NEWTON AVE
RIVER CROSSING

PROPOSED CHAMBER

PROPOSED DETAILS

BENBEE
Diving & Marine Ltd.

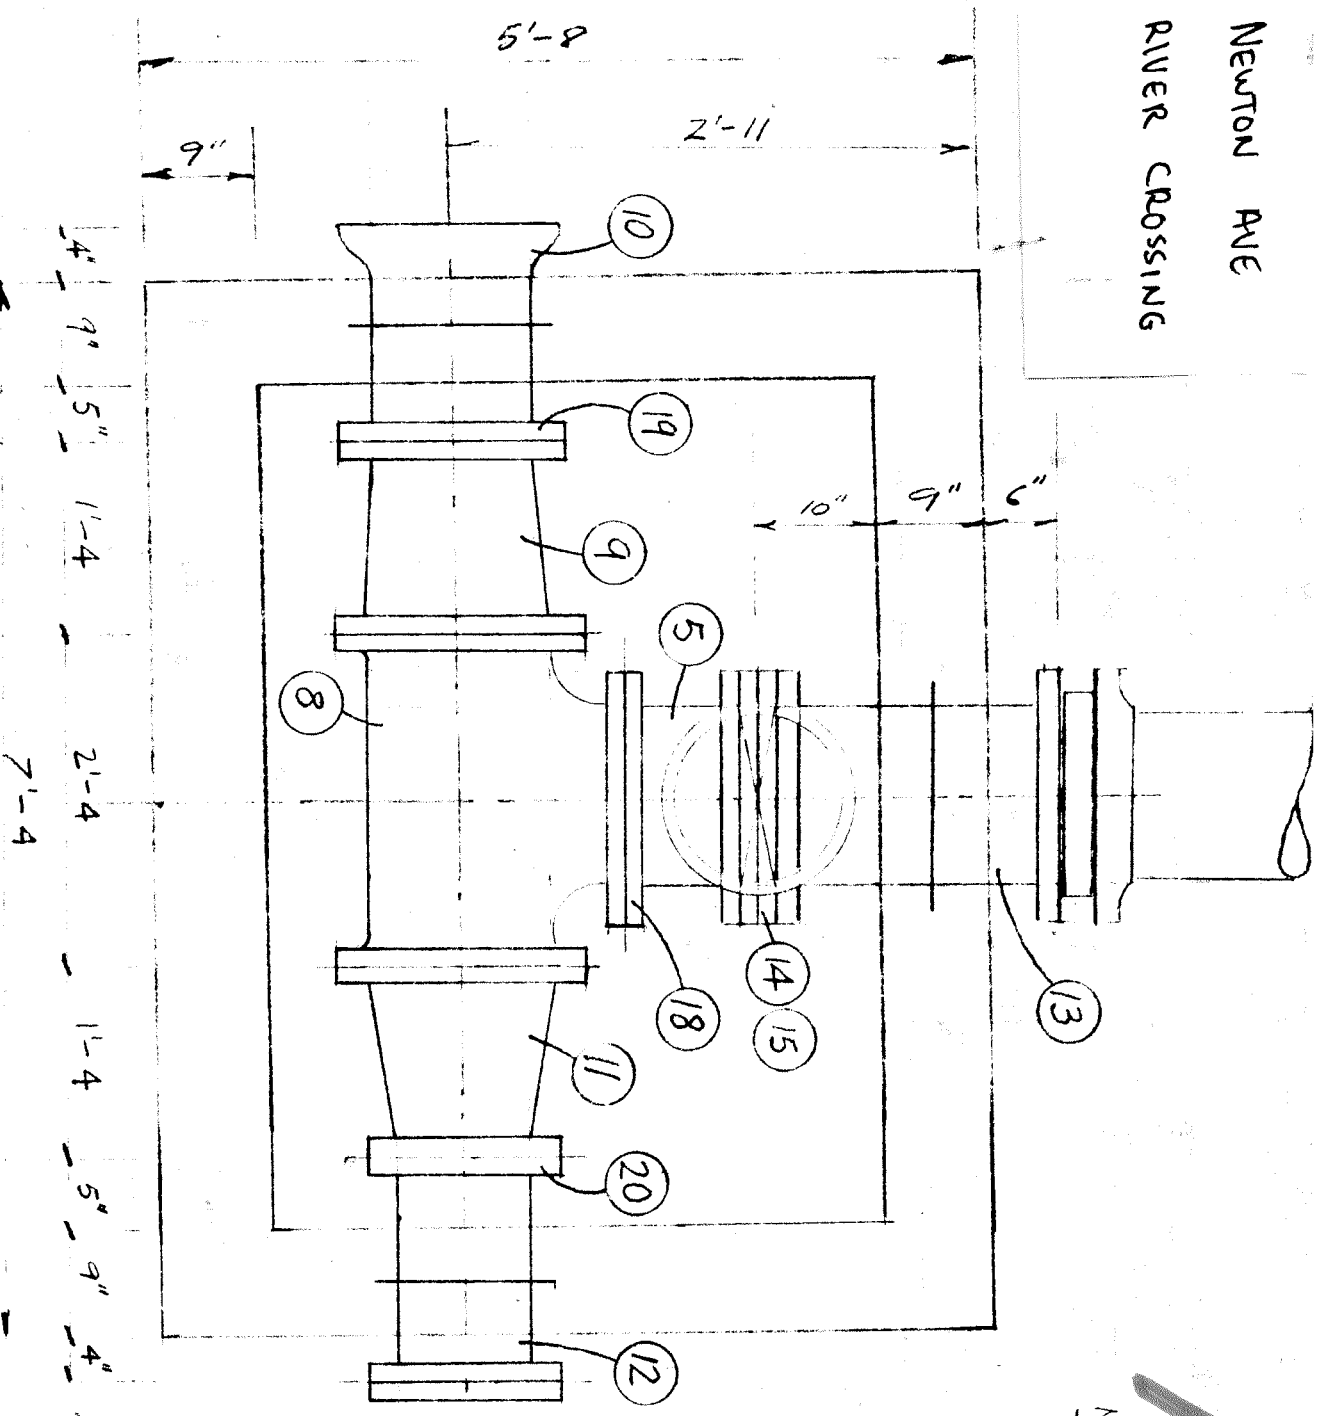
THE CITY OF WINNIPEG
WATERWORKS, WASTE & DISPOSAL DIVISION
APPROVED FOR CONSTRUCTION
Dan Wucher DATE *Nov. 9/77*
Approval of this drawing covers only the general design and arrangement of material or equipment and does not in any way relieve the Contractor of any liability or responsibility for the satisfactory operation of this installation.
